Meeting Date:
October 13, 2025

Location:
41 E. Main Street

Request:
Major Site Plan

Hudson Planning Commission	SITE PLAN REVIEW – VILLAGE DENTAL
Case No. 25-1022	October 13, 2025

Fig 2

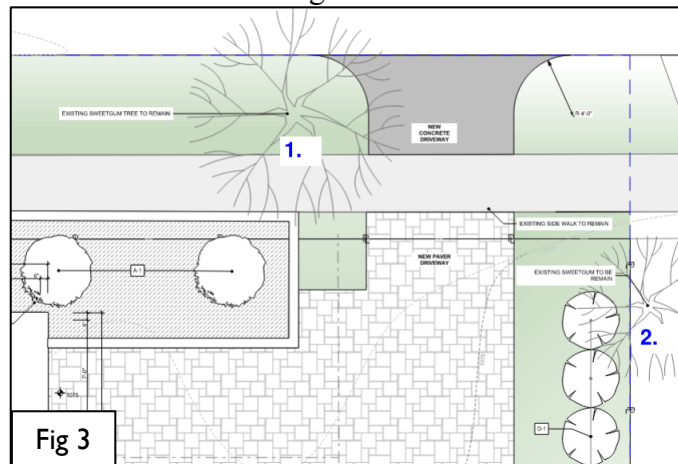
Staff Comment: Staff notes the proposal would relocate an existing curb and provide additional separation from E Main Street; however, it will result in 3 consecutive curb cuts along Division Street (See Figure 2).

While there is no specific code issue on this item, question if the applicant has explored the feasibility of a shared access easement with the adjacent driveway to the east. This would eliminate the concern for multiple driveway aprons and ensure the mature street tree is protected as further described on page 6.

1. Design of the addition will require final approval by the Architectural and Historic Board of Review.
2. Provide documentation that it is infeasible to eliminate the proposed driveway curb cut.

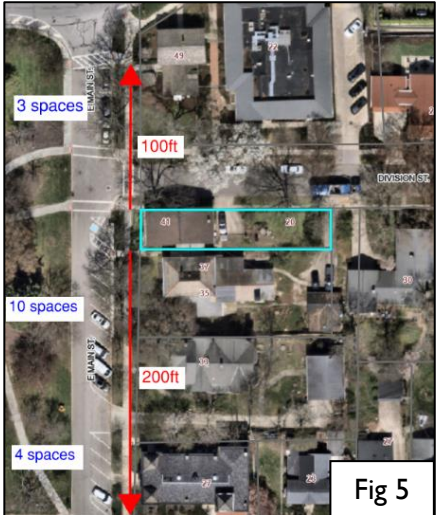
Staff notes existing landscaping would be removed along the eastern property line depicted in Figure 4 below. This landscaping would be replaced by 6 Korean Spice Viburnums. Staff recommends evergreens be planted in lieu or in addition to the viburnums to help buffer the adjacent residential homes to the east.

3. Provide additional documentation regarding protection measures for the existing Sweetgum tree identified in Figure 3 of this report.
4. Revise the landscaping drawings to incorporate evergreens along the eastern property line.
